ORIGINATION FORM

Proposed Revisions to a Standard Plans Index
(Please provide all information — Incomplete forms will be returned)

Index Number: 415-001

Index Title: Bar Bending Details (Steel)

Spiral

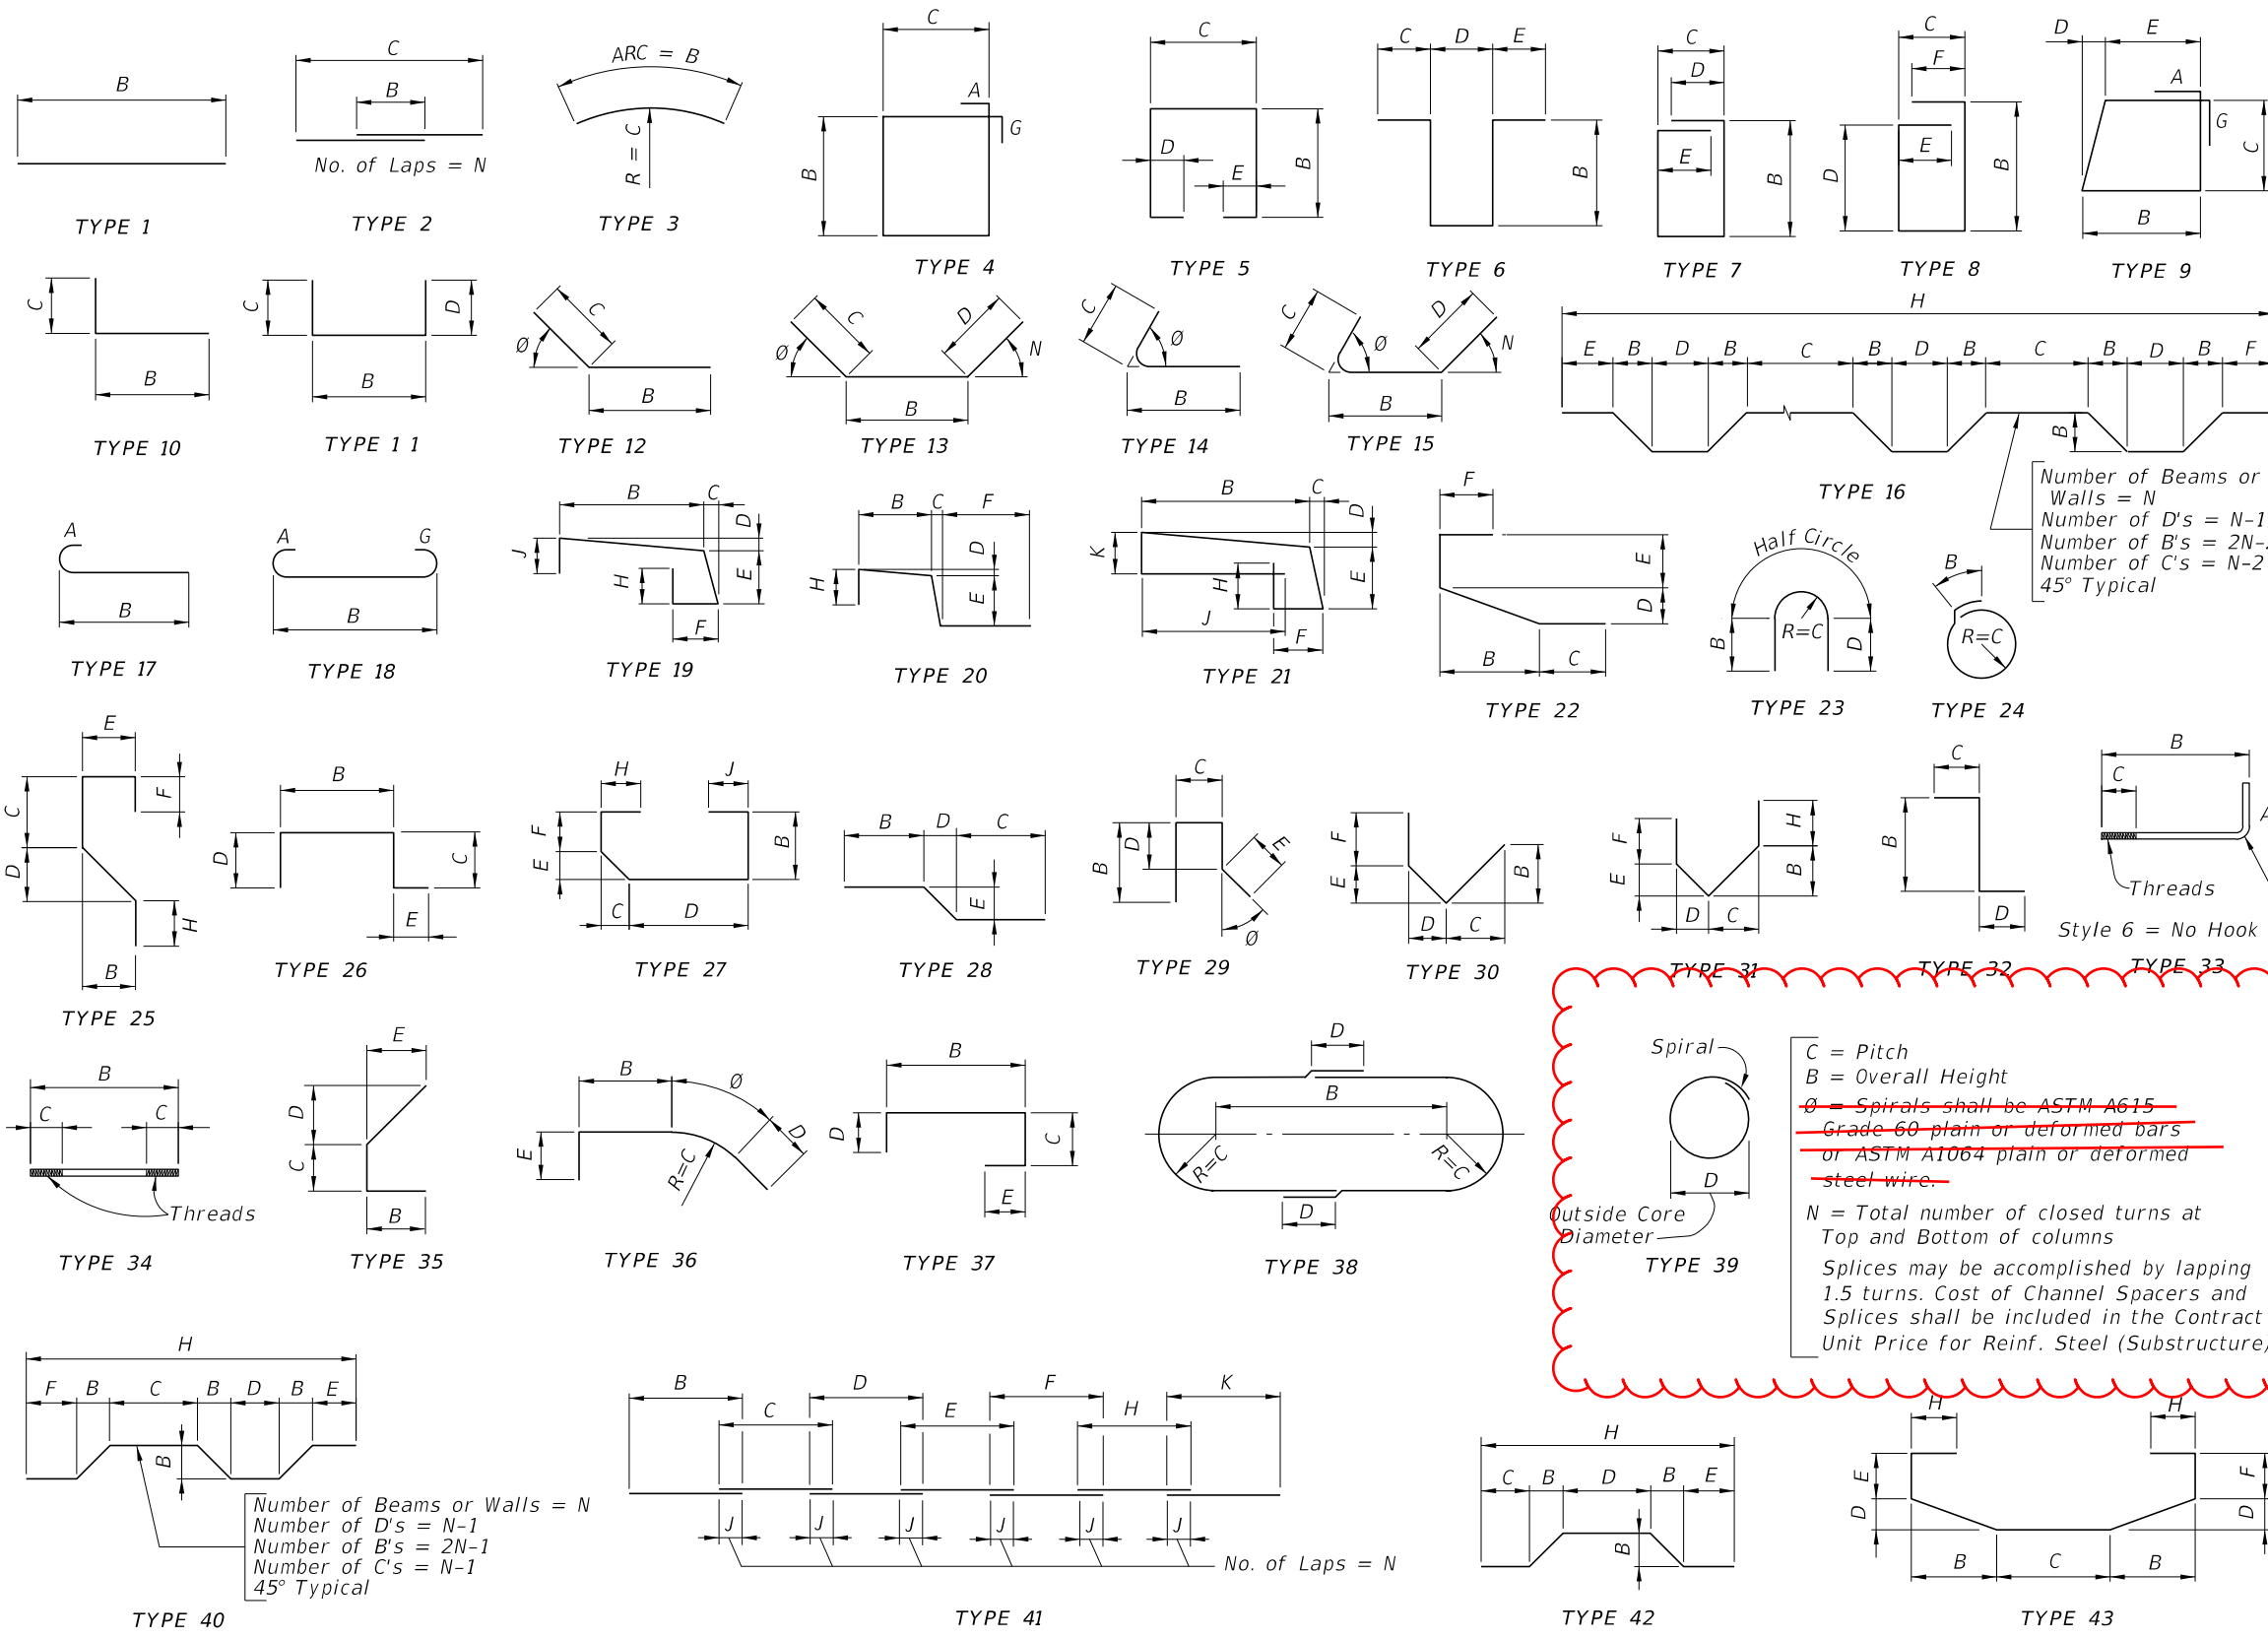
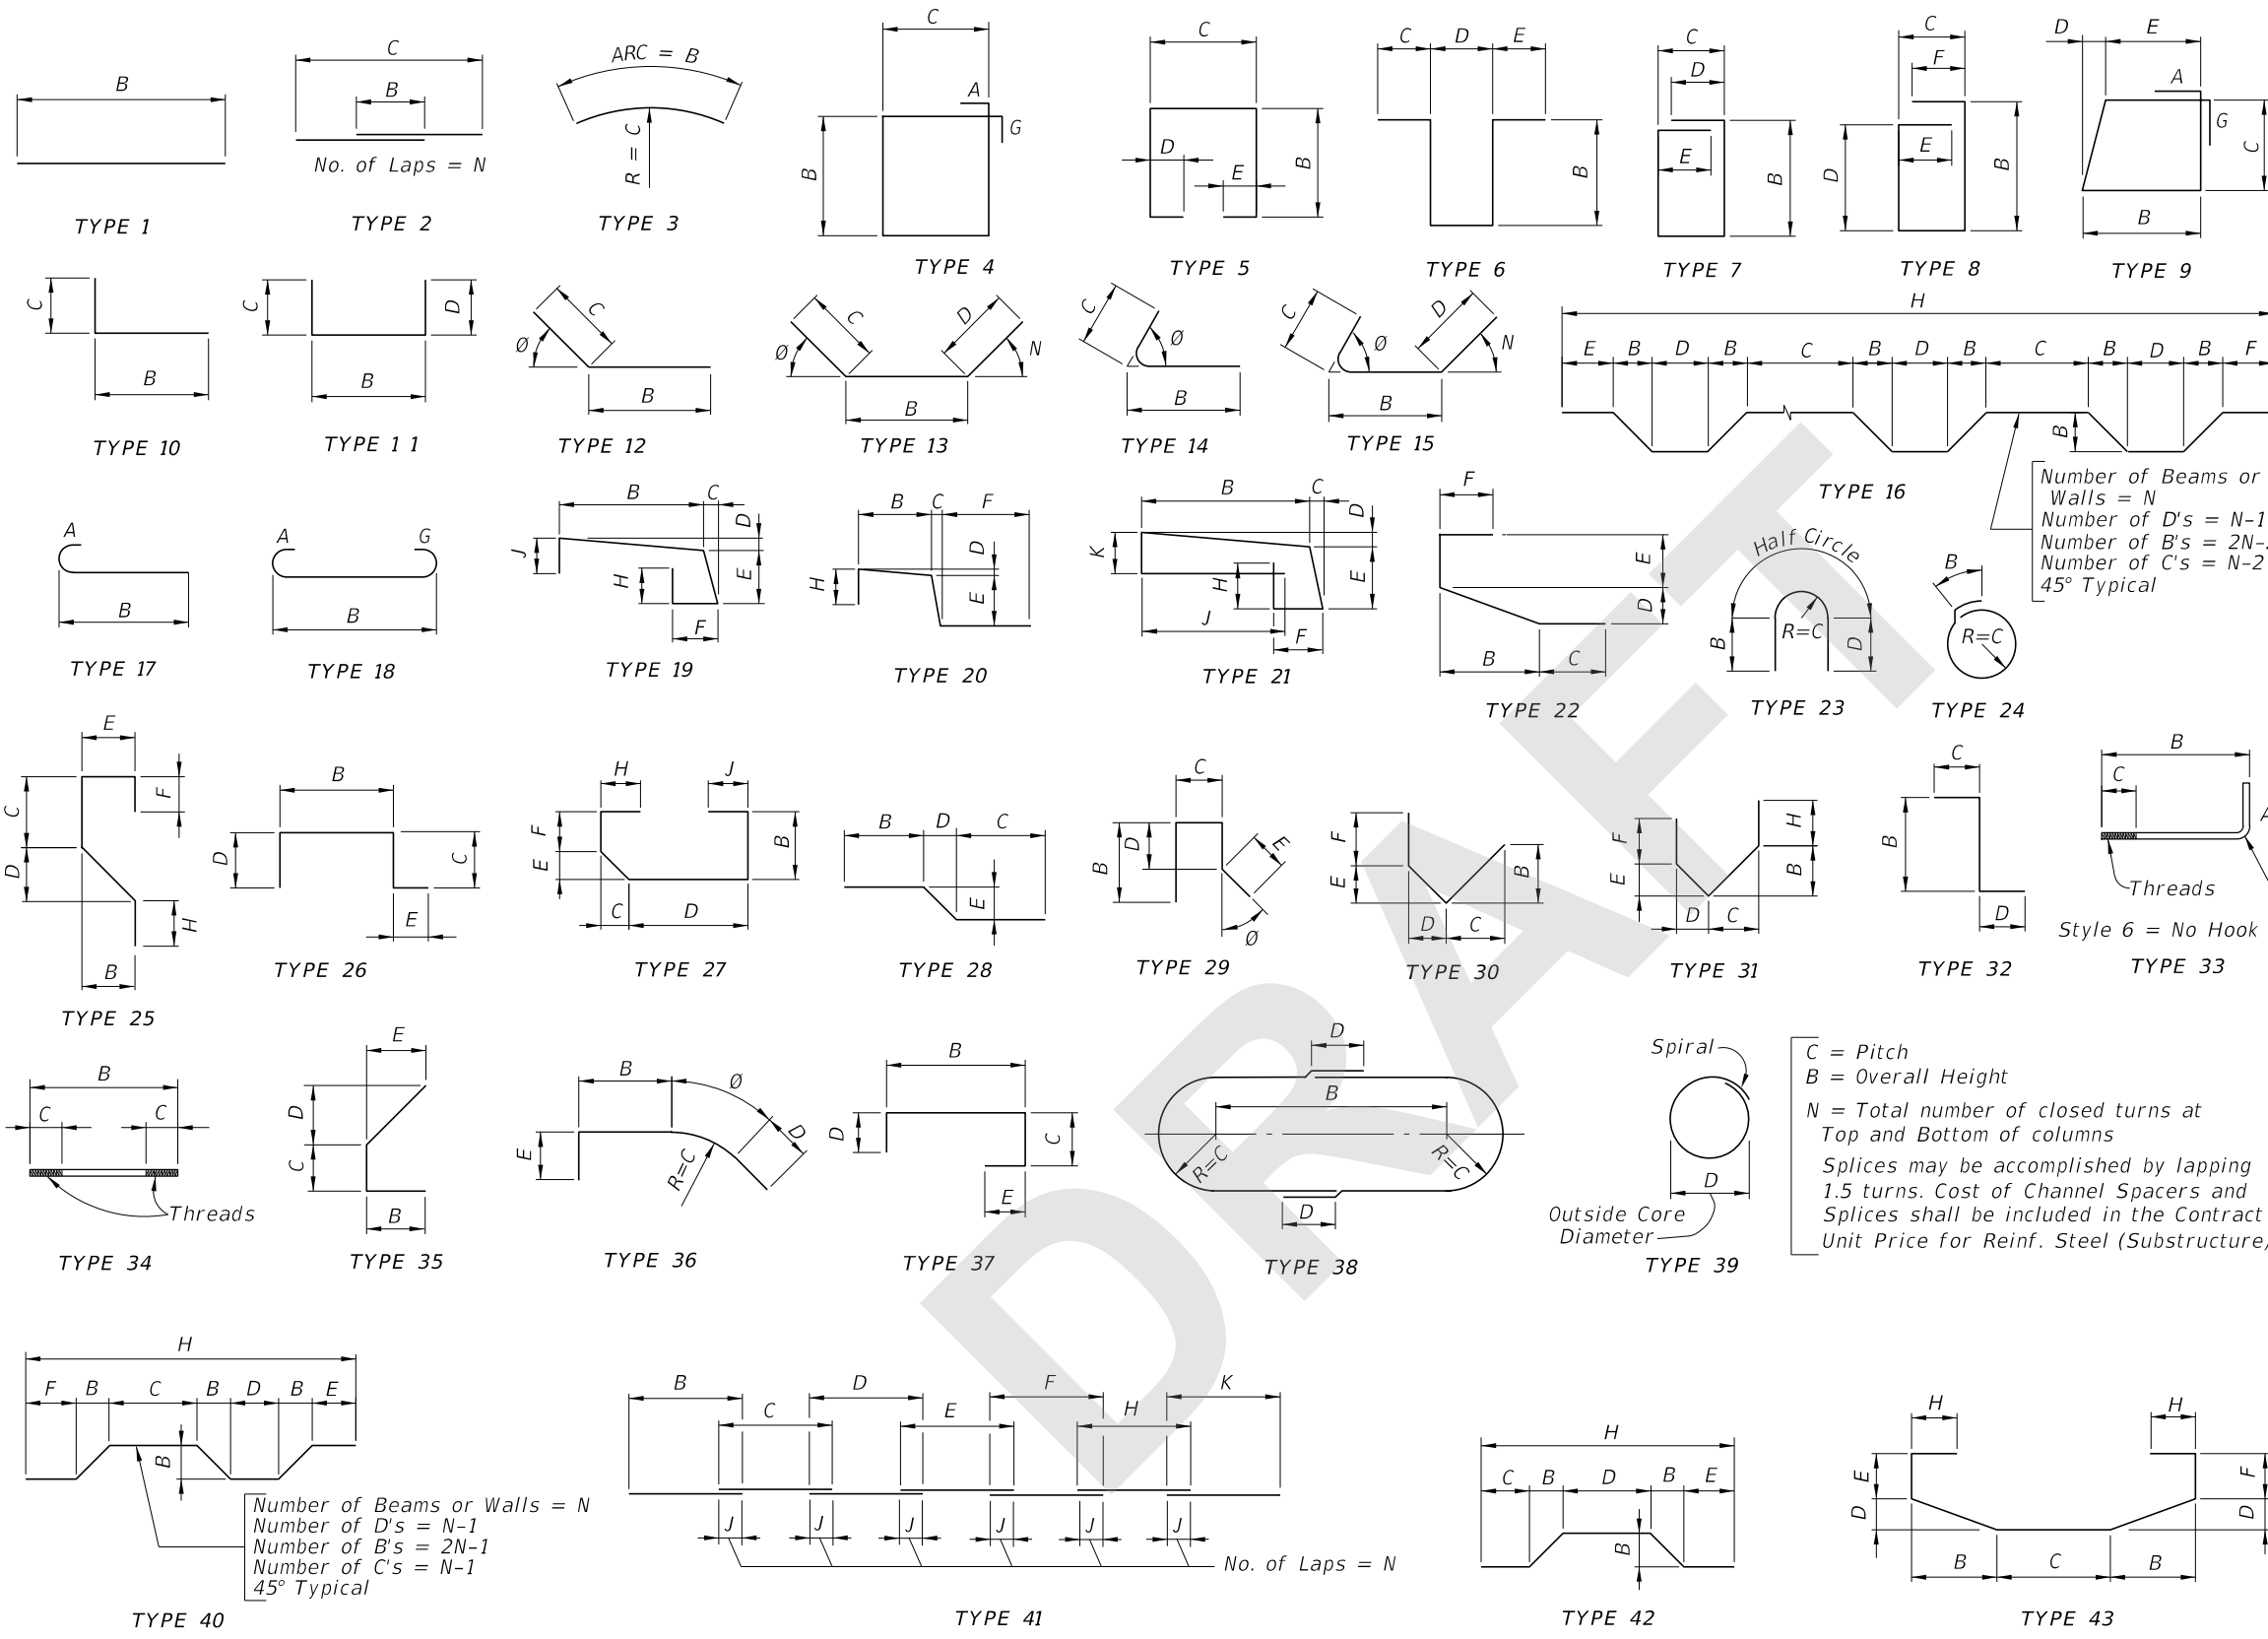
Delete phi for Type 39 spiral

Phi was the grade which is now covered in the standard and SDG. Bar or wire is at the contractors discretion.

C = Pitch
B = Overall Height
~~Ø = Spirals shall be ASTM A615~~
~~Grade 60 plain or deformed bars~~
~~or ASTM A1064 plain or deformed steel wire.~~
